SUBJECT: Clarksburg Village, Phase 1 (Site Plan No. 8-03002)

Re: **Final Water Quality Plan for Clarksburg Village-Phase I**
SM File #: 200006
Preliminary Plan No.: 1-01030
Tract Size, Zone: 333 Ac., R-200/TDR-4, R-200/TDR-3, R-200 and PD-4
Tax Plate: EW, EV, FV 123 and FV 122
Watershed: Little Seneca Creek

**Attachment to the Final Water Quality Plan for Clarksburg Village Phase I
Description of BMP Monitoring Requirements**

**NAME OF PLAN: CLARKSBURG VILLAGE AND SPECIAL PROTECTION AREA WATER
QUALITY PLAN**

Newcut Road Neighborhood Land Use Plan

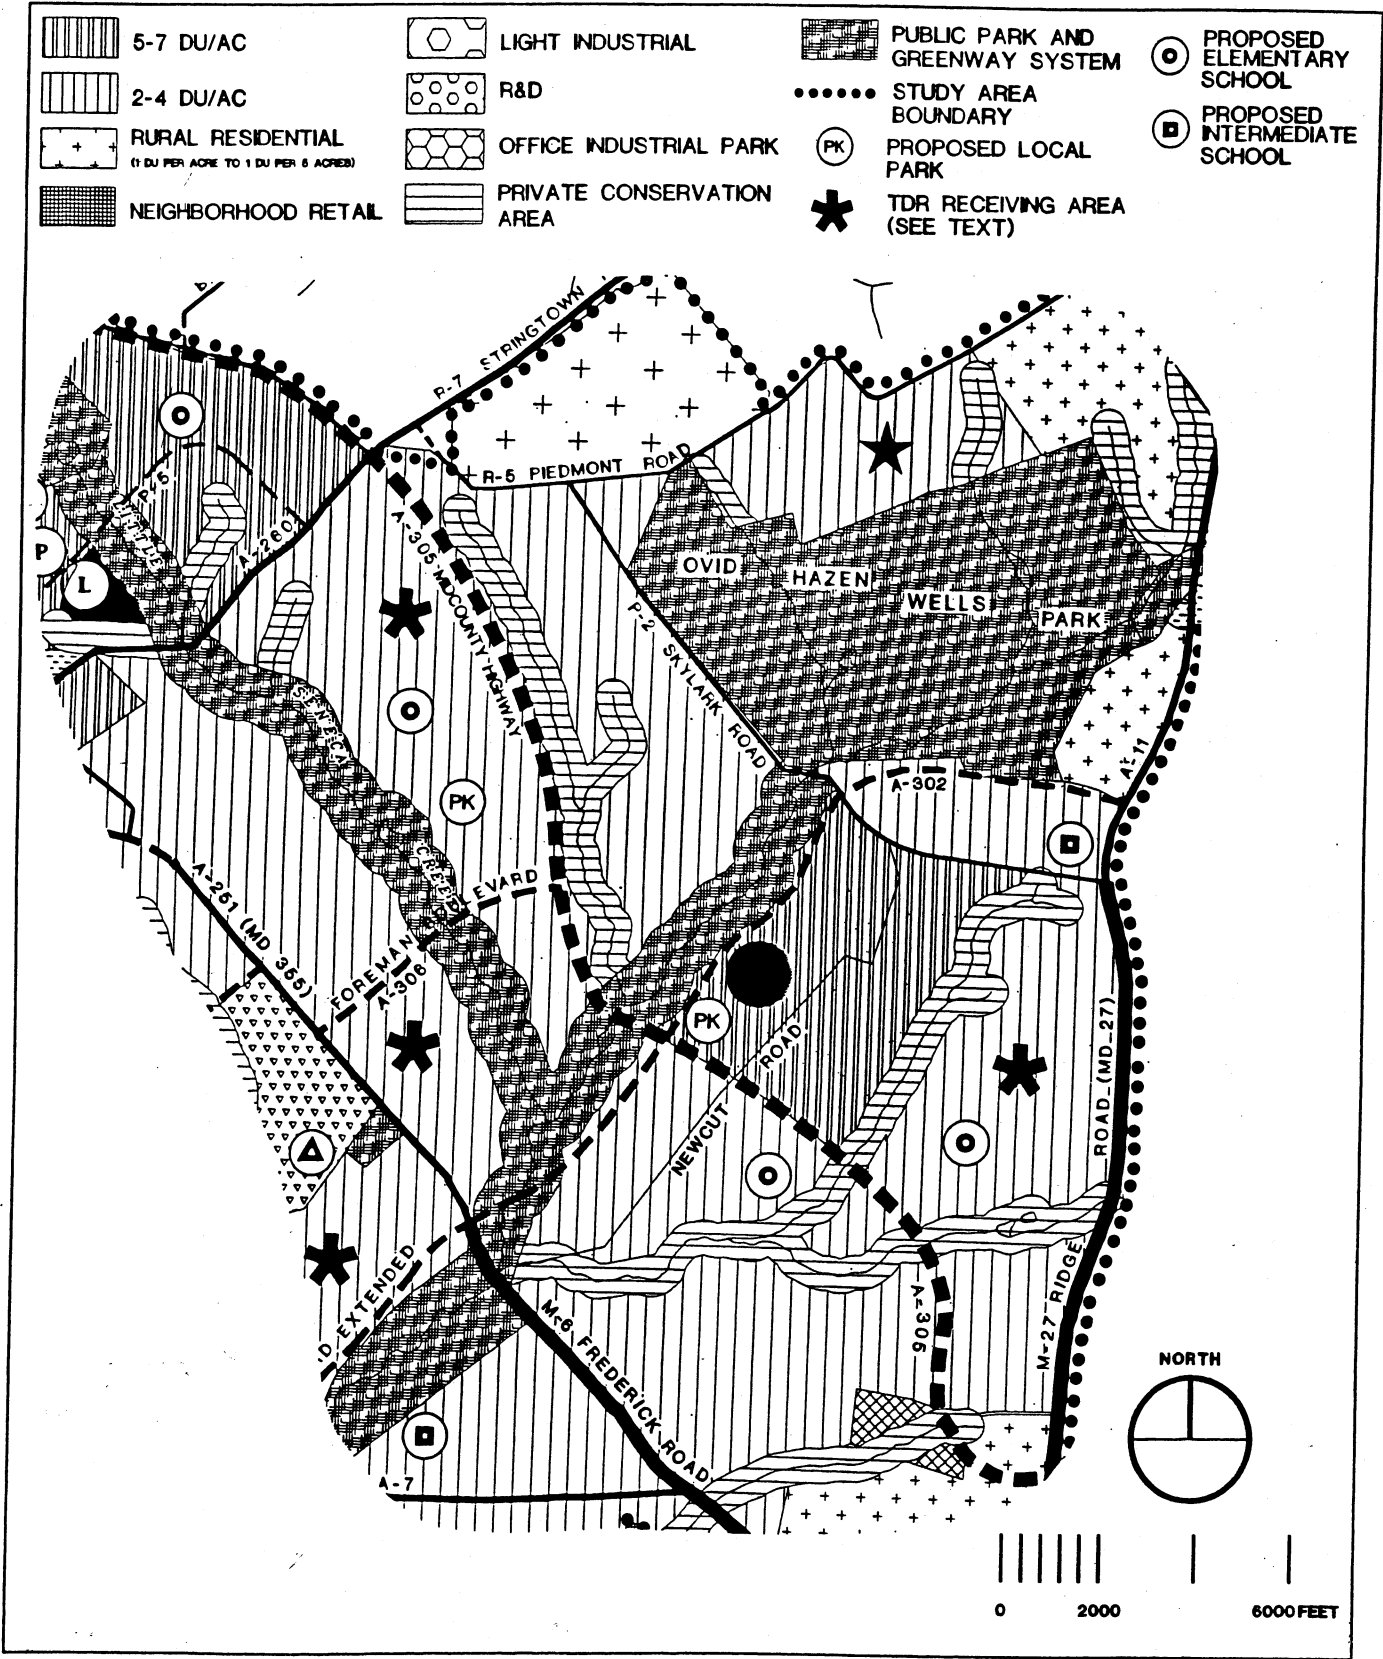
As shown in Figure 1, the land use recommendations for the Newcut Road Neighborhood propose a mixed-use center on Newcut Road, approximately midway between A-305 and Skylark Road. This will provide a concentration of activity and density in the middle of the neighborhood while promoting lower densities at the edges. This concept also clusters development near the greenway system and enhances public access to Ovid Hazen Wells Park.

The Master Plan emphasizes bikeway access from neighborhoods to shopping and employment areas as well as to key community facilities. The applicant should provide a bikeway connection through the greenway trail to the adjacent Greenway Village community, Ovid Hazen Wells Regional Park, and the proposed elementary school. This will improve access to the neighborhoods, school, and the park.

The Greenway bikeway trail needs to run under A-305 within a structure and continue up to the Greenway Village community. Connections to the Greenway bikeway trail need to be shown from the traffic roundabout.
